ADAMS CREEK COHOUSING, LLC  
**ADAMS CREEK COHOUSING**  
1419 SHERMAN AVENUE  
HOOD RIVER, OREGON 97031

### Narrative for Site Plan Review | Revised 04.30.20

Subject: Response to "Notice of Incomplete Application" dated March 4, 2020  
Project: Adams Creek Cohousing, 1419 SE Sherman Ave, 03N10E35AA Tax Lot 4900

Subject: Response to Notice of Incomplete Application dated May 28, 2020  
Project: Adams Creek Cohousing, 1419 SE Sherman Ave, 03N10E35AA Tax Lot 4900

**1 BUILDING 1 - NORTH ELEVATION**  
1/8" = 1'-0"

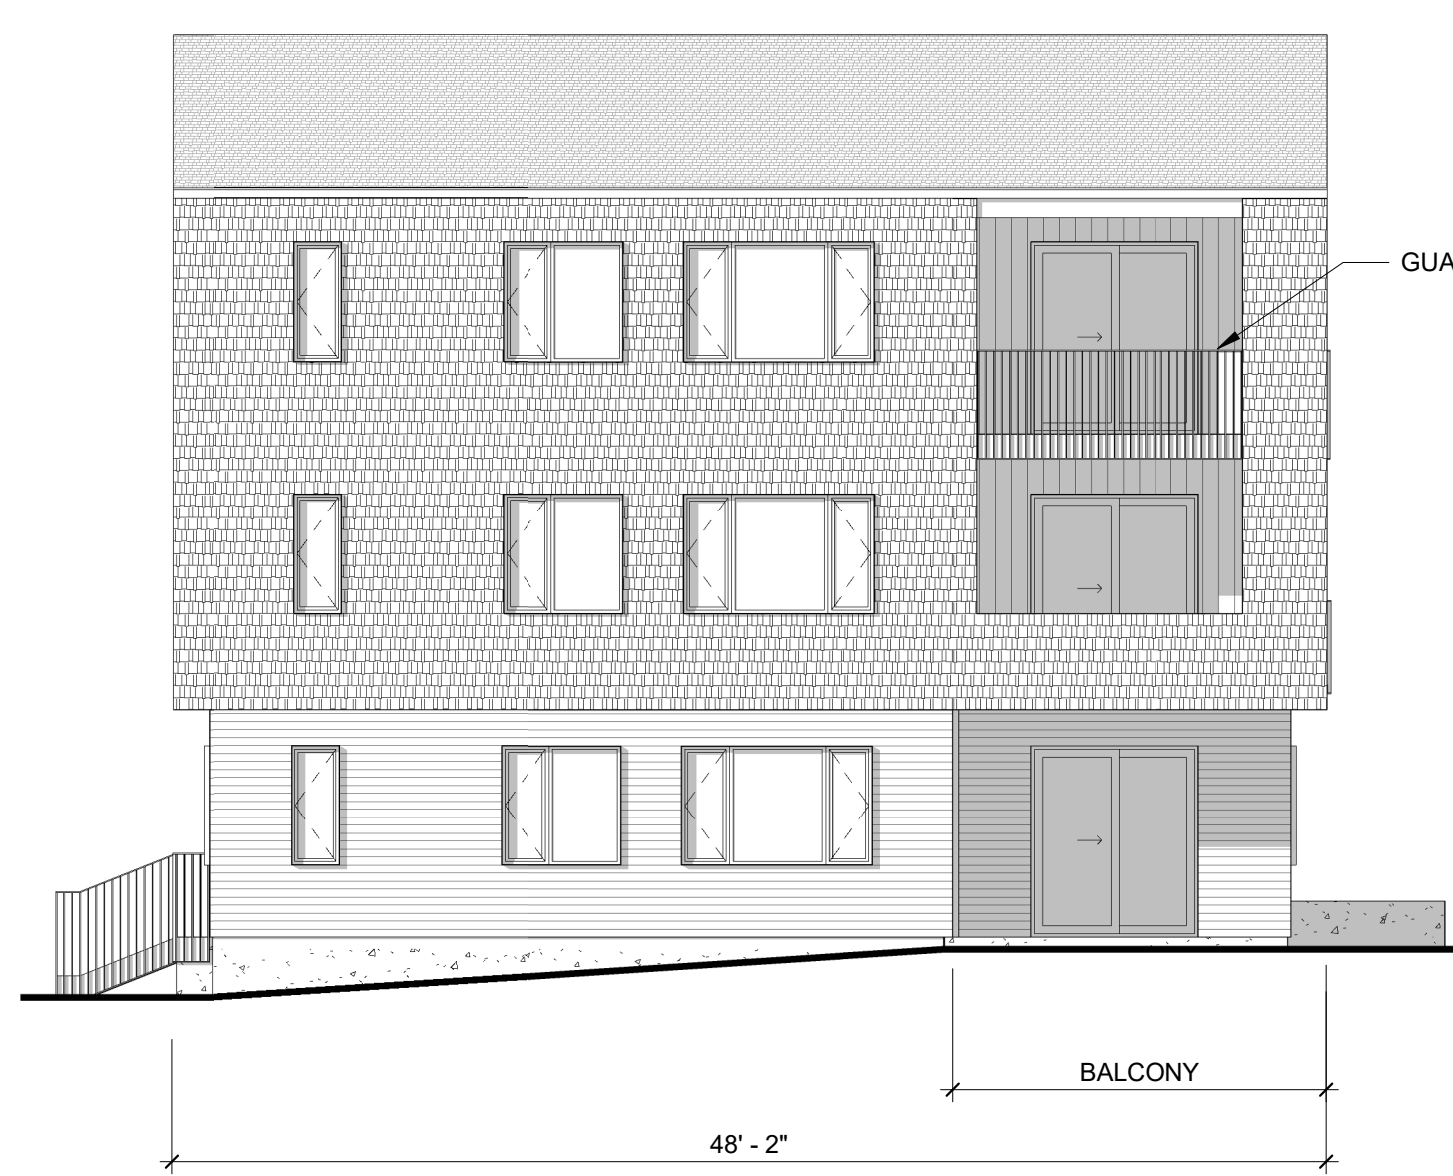
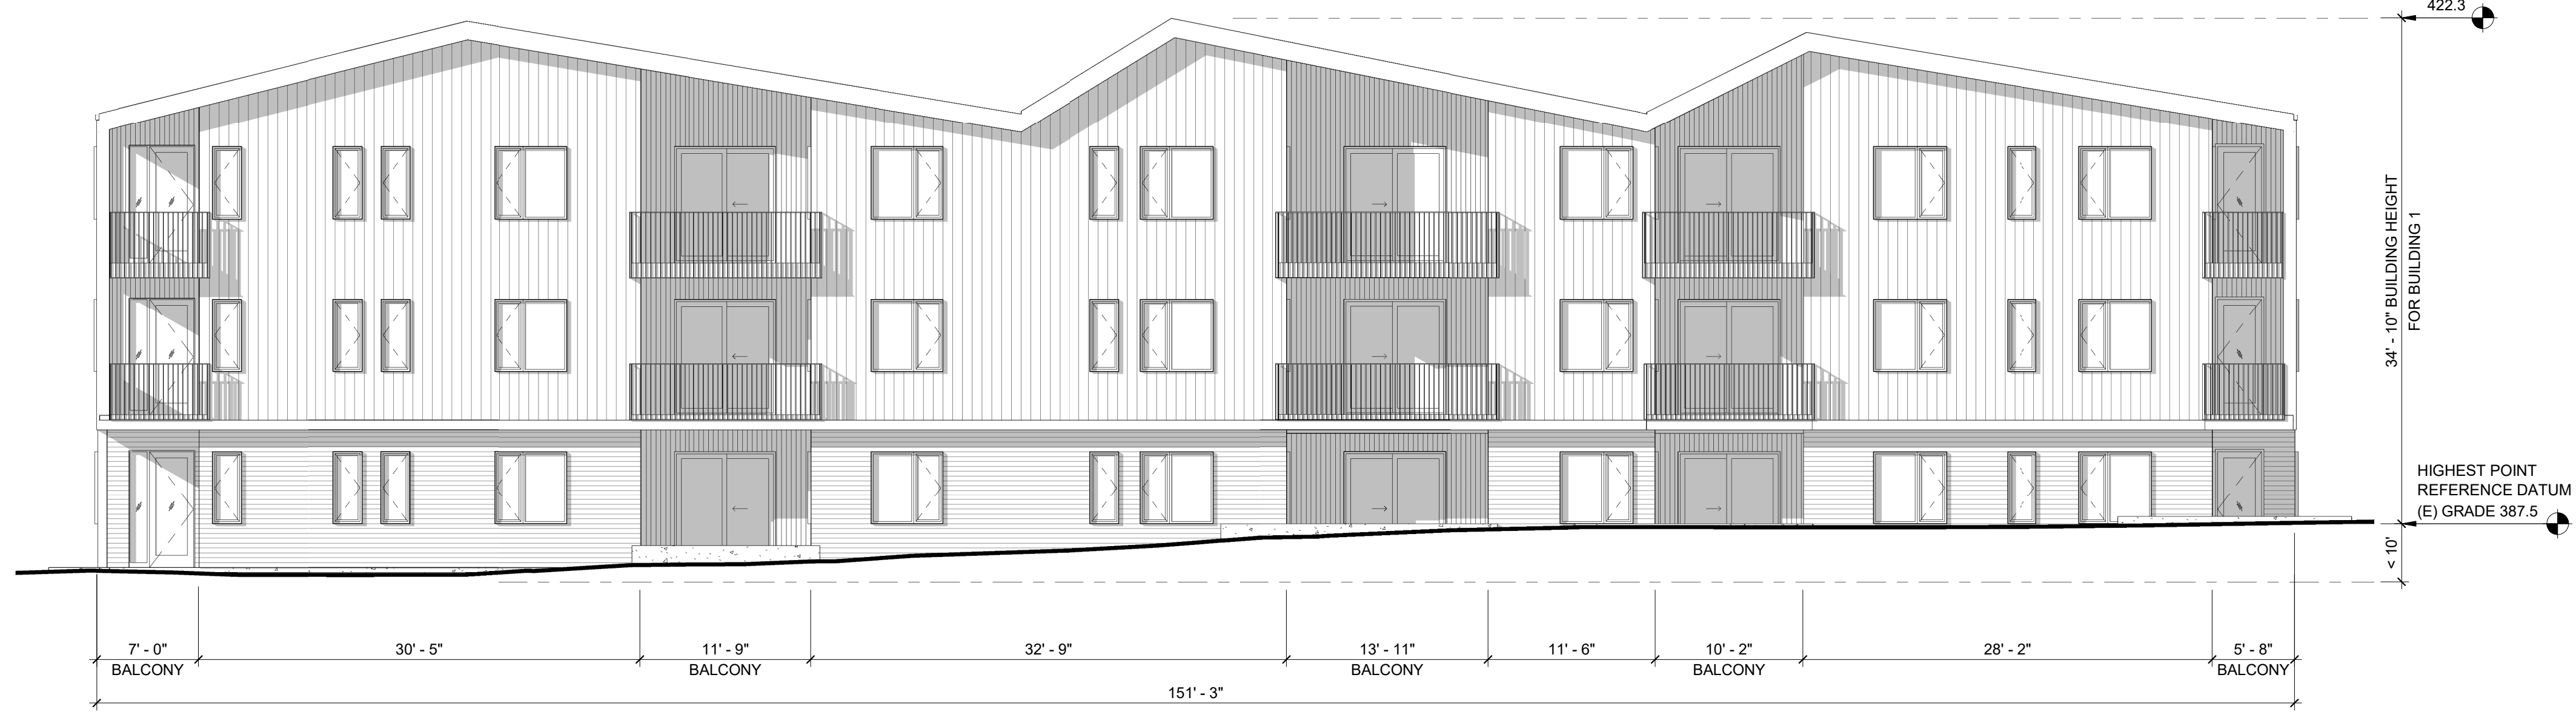
- **Elevations for accessory structures.** Elevations of the proposed Recreation Building and Carport have been added to the submittal.
- **Façade length and variation.** Additional building design notations have been added to the elevations and site plan. See the building elevation legend for materials. See also the expanded narrative.

**PRELIMINARY SITE AND LANDSCAPE PLAN**

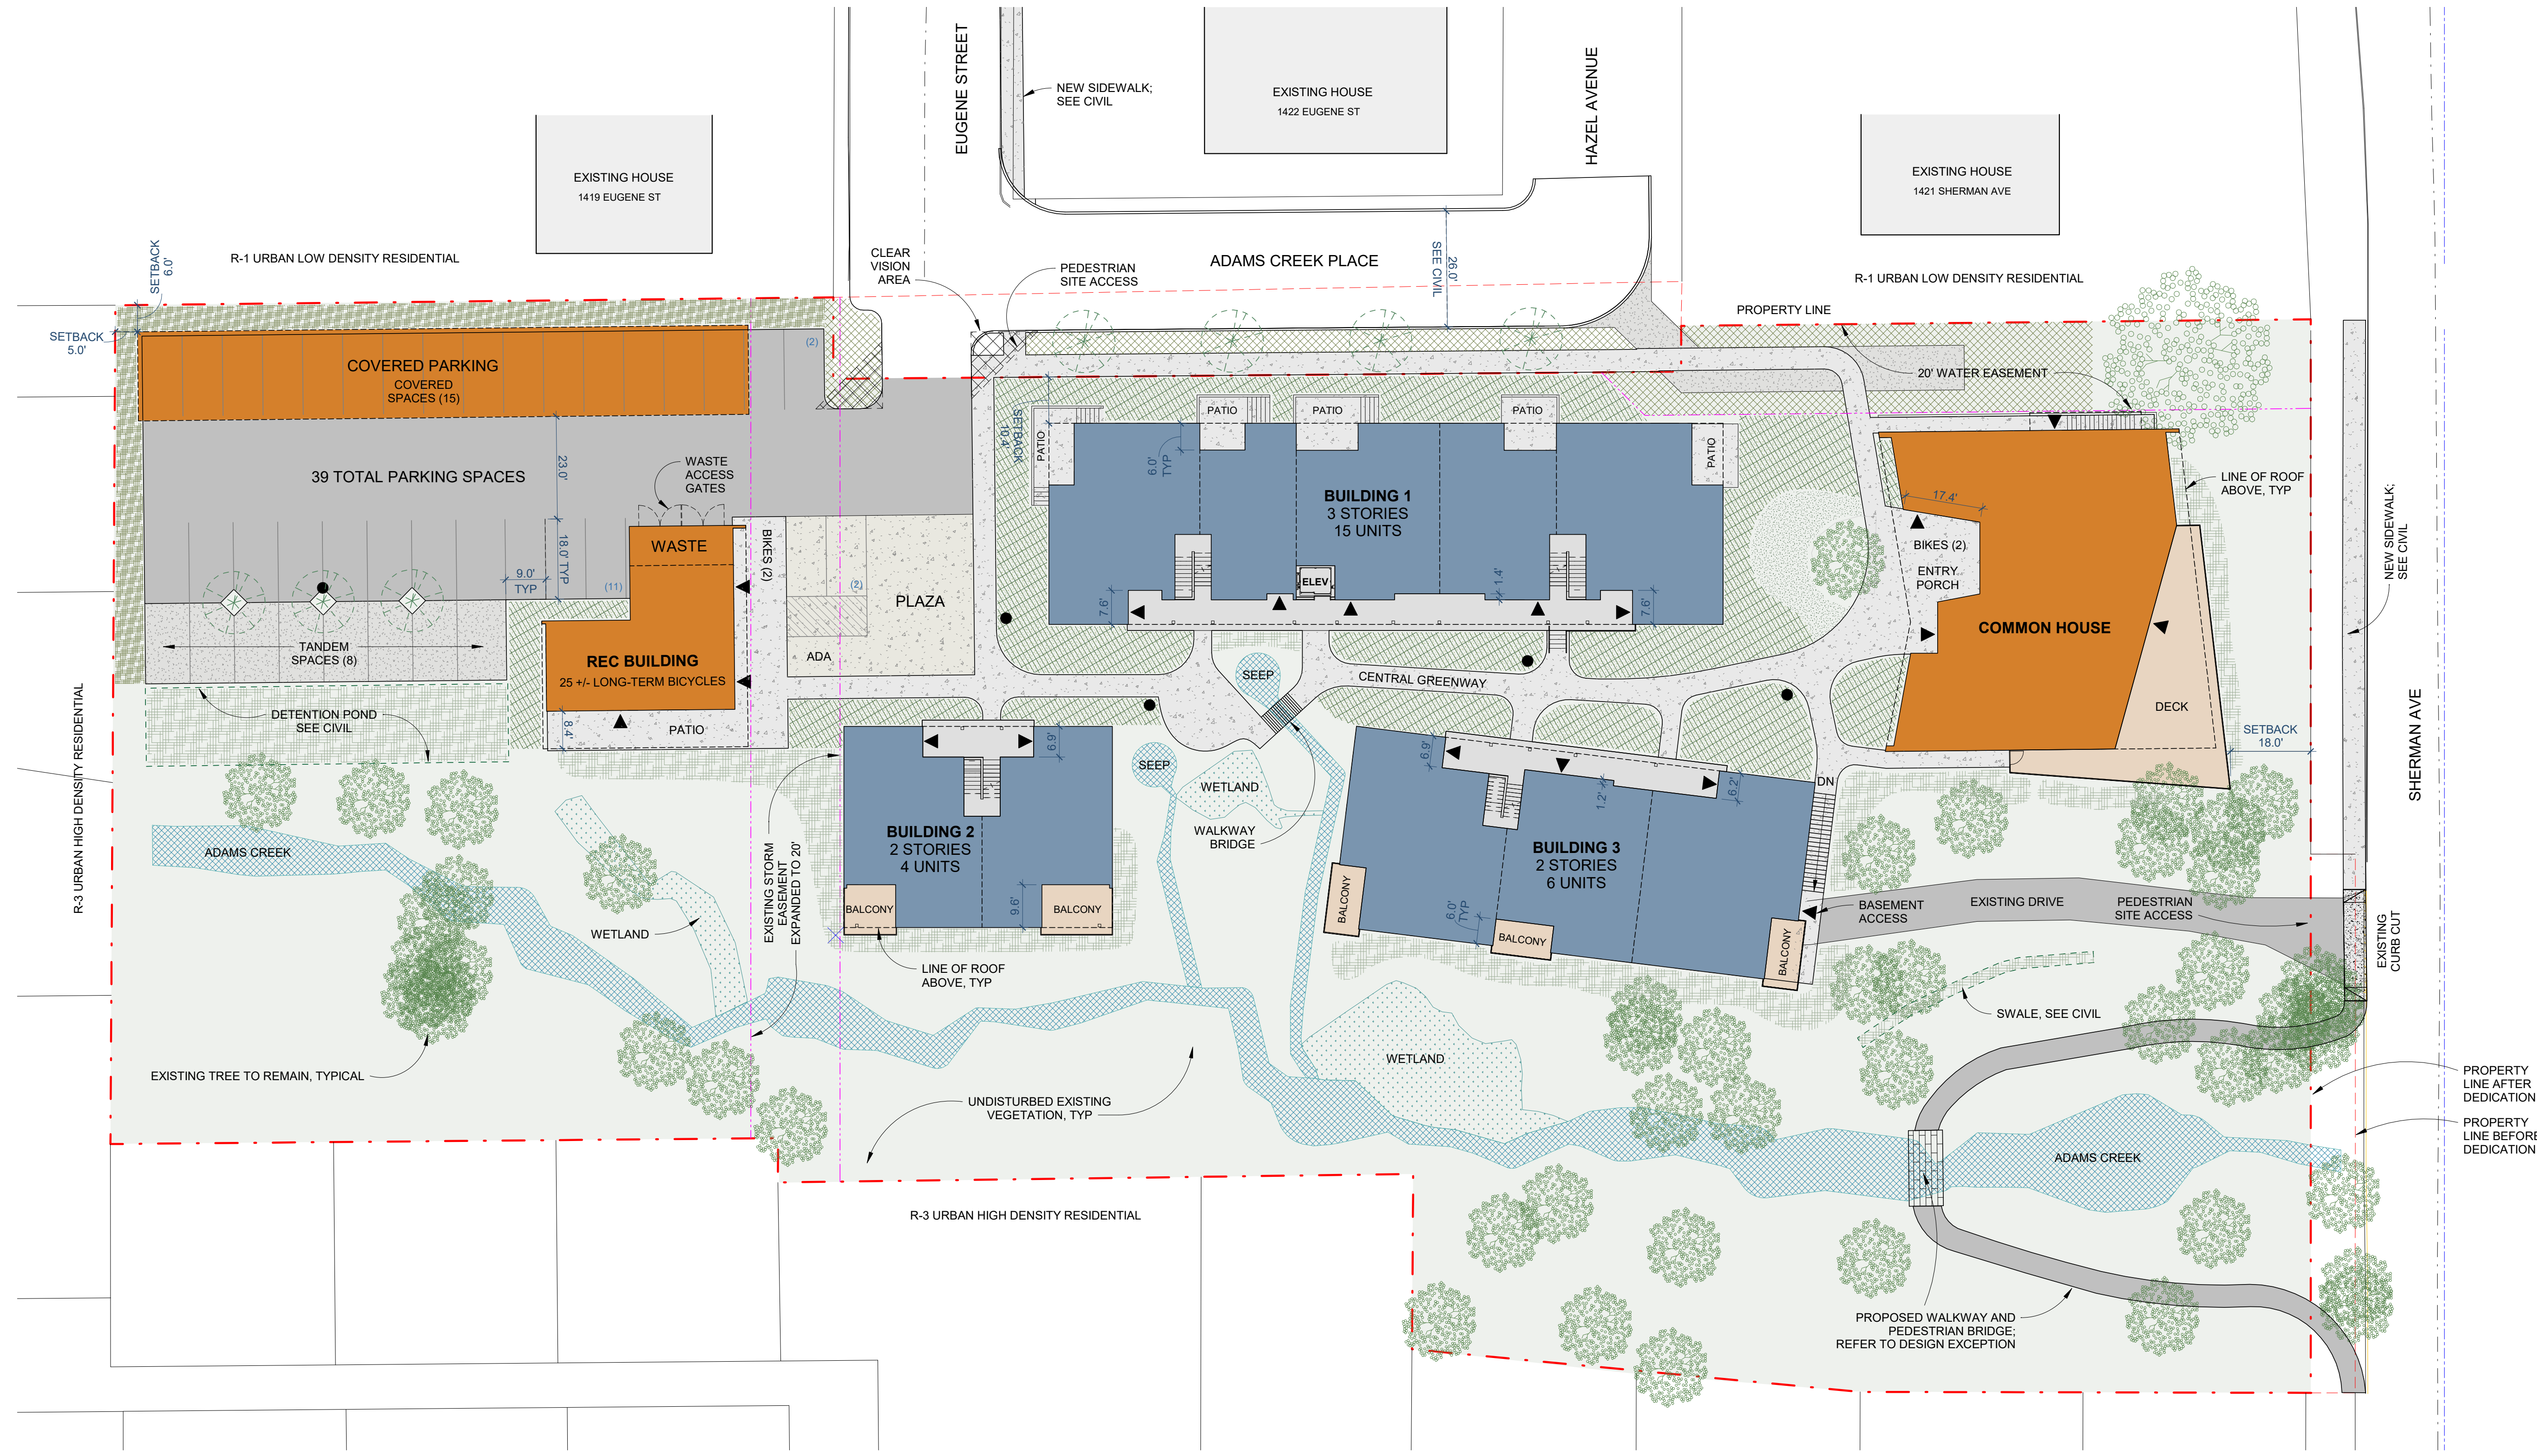
- **Parking spaces off Sherman Ave.** These two spaces have been removed. The primary parking area has been expanded accordingly. See revised narrative and site plan.

- **Existing and proposed grade elevations.** To assist in evaluating building height, additional elevation data has been provided on the building elevations.
- **Building footprint dimensions.** Overall building dimensions have been provided on the building elevations.
- **Freestanding light fixtures.** Freestanding light fixture locations have been provided on the site plan.
- **Proposed parking aisle width.** Parking lot dimensions have been added to the site plan.
- **Proposed site surfaces.** A legend indicating proposed surface materials has been added to the site plan.

- **Summary of plant material.** Plant material descriptions are provided in the narrative and are coordinated with the site plan legend. See the site plan for revised locations.
- **Area summary.** Total areas of proposed landscaping and areas of natural condition have been added to the narrative.
